SUBJECT: ISSUANCE OF AMENDMENTS NOS. 180, 180, AND 177 TO FACILITY OPERATING LICENSES DPR-38, DPR-47, and DPR-55 - OCONEE NUCLEAR STATION, UNITS 1, 2, AND 3 (TACS 75074/75075/74887)

These amendments revise the TSs to account for minor changes in power peaking and control rod worths resulting from the Oconee Unit 3 core reload. In addition, the use of the VIPRE thermal hydraulic code is referenced and all specifications associated with two reactor coolant pump operations are deleted.

SAFETY EVALUATION BY THE OFFICE OF NUCLEAR REACTOR REGULATION
RELATED TO AMENDMENT NO.180 TO FACILITY OPERATING LICENSE DPR-38

OCONEE NUCLEAR STATION, UNITS 1, 2 AND 3

Figure 2.1-2
OCONEE NUCLEAR STATION

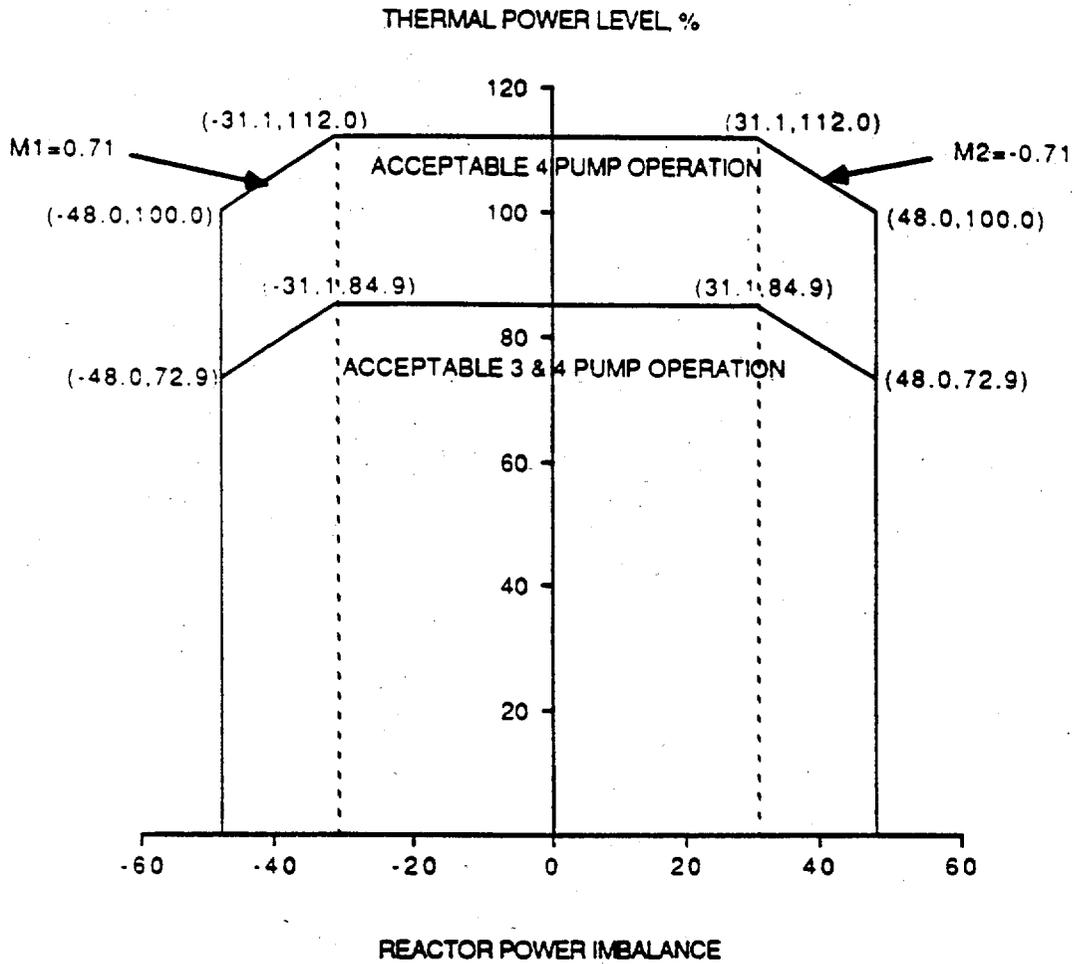
Since power peaking is not a directly measurable quantity, DNBR limited power peaks and fuel melt limited power peaks are separately correlated to measurable reactor power and power imbalance. The reactor power imbalance limits,

Figure 2.1-2(5), define the values of reactor power as a function of axial imbalance that correspond to the more restrictive of two thermal limits - MDNBR equal to the DNBR limit or the linear heat rate equal to the centerline fuel melt limit.

The core protection safety limits are based on an RCS flow less than or equal to 385,440 gpm (4 pump operation). Three pump operation is analyzed assuming 74.7 percent of four pump flow. The maximum thermal power for three pump operation is 84.9 percent (Figure 2.1-2) due to a power level trip produced by the flux/flow ratio (74.7 percent flow x 1.07 = 79.9 percent power = 84.9 percent power adding the maximum calibration and instrument error).

The licensee performed the reload analysis using the approved reload design methodology described in DPC-NE-1002A, "Oconee Nuclear Station Reload Design Methodology II." The flux/flow/imbalance safety limit change is necessary because of the minor changes in the power peaking and control rod worth. The changes in safety limits also affect the limiting safety system settings. The flux/flow/imbalance safety limit change is a result of maneuvering analysis on fuel depletion, integral rod worth, and power maneuver. For the four-pump operation, the maximum power imbalance is reduced from the current value of 49.5 percent to 48 percent. For three-pump operation, the maximum allowable power level is reduced from 88.07 percent to 84.9 percent. The calculation of the allowable power level for the three-pump operation is based on an assumed reactor coolant system flow rate of 74.7 percent of the rated flow, a flux/flow trip setpoint of 1.07, and a power measurement uncertainty of 5 percent. This method is the same as that for the previous cycles except that the power uncertainty of 5 percent is obtained using the square root of sum of the squares method to account for the uncertainties associated with heat balance error, TS allowance for calibration of the excore detectors to the heat balance, transient nuclear instrument error, and an allowance for the uncertainty of the flux/flow imbalance trip function hardware. Since the error adjustment of the flux/flow/imbalance safety limits would result in a setpoint of 79.9 percent, the same as the current Reactor Protection System (RPS) maximum allowable setpoint, the RPS allowable setpoint in Figure 2.3-2 was unchanged.

Figure 2.3-2

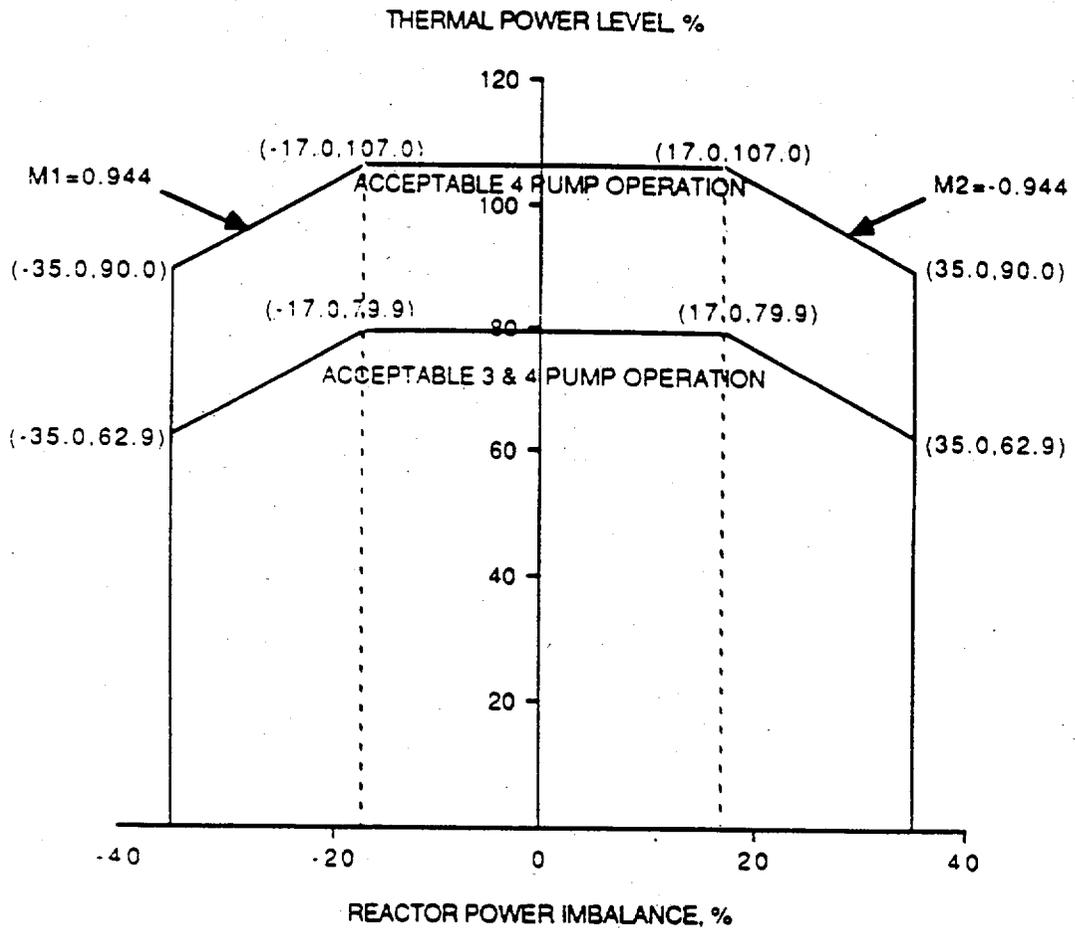
The reactor power imbalance (power in the top half of the core minus the power in the bottom half) reduces the power level trip produced by the flux/flow ratio as shown in Figure 2.3-2. The flux/flow ratio reduces the power level trip and associated power-imbalance boundaries by 1.07% for a 1% flow reduction. The power-imbalance boundaries shown in Figure 2.3-2 are established to prevent fuel thermal limits, DNBR and centerline fuel melt limits, from being exceeded.
